Service Bulletin SB-3

February 19, 2004

This service bulletin describes an inspection of SAFE-HEET engine pre-heaters for indications of electrical short and subsequent damage to the engine oil pan. In addition, measures are provided to prevent future damage. Non-compliance could result in engine oil loss and subsequent engine failure.

Figure 1: Typical indications of electrical damage.

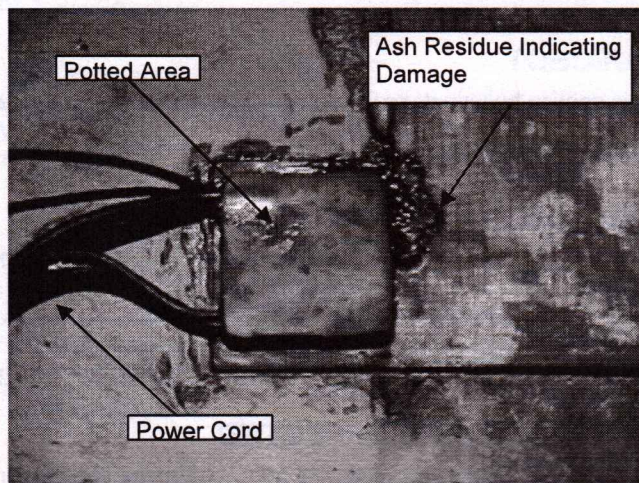
- 2) With an Ohm meter at the 10kΩ setting, **verify that there is no continuity** between the round ground prong and either flat prong.
- 3) Visually inspect the area of the pre-heater in the vicinity of the ¼-inch thick power cord potting for any signs of a burned, charred or over-heated area. The burned area will exhibit a dark brown or black color. An area that was over-heated may be a lighter shade of orange than the surrounding heat pad. See Figure 1 for typical signs of damage.

- 4) Visually inspect the area of the pre-heater in the vicinity of the ¼-inch thick power cord potting for any signs of oil leakage.
- 5) If Steps 1 through 4 indicate damage or oil leakage, then perform Steps 5a through 5c:

- a) Remove the SAFE-HEET and any adhesive in the area of the ¼-inch thick power cord potting from the oil pan.
 - b) Inspect the oil pan where the ¼-inch thick pre-heater power cord potting was, for indications of damage caused by electrical erosion or arcing. If arcing damage is present, then repair or replace the oil pan.

- c) Replace the removed pre-heater with a new SAFE-HEET Model 7XX where XX indicates the last two digits of the model number removed. Model 7XX series engine pre-heaters now include SAFE-HEET Service Kit 709SK.
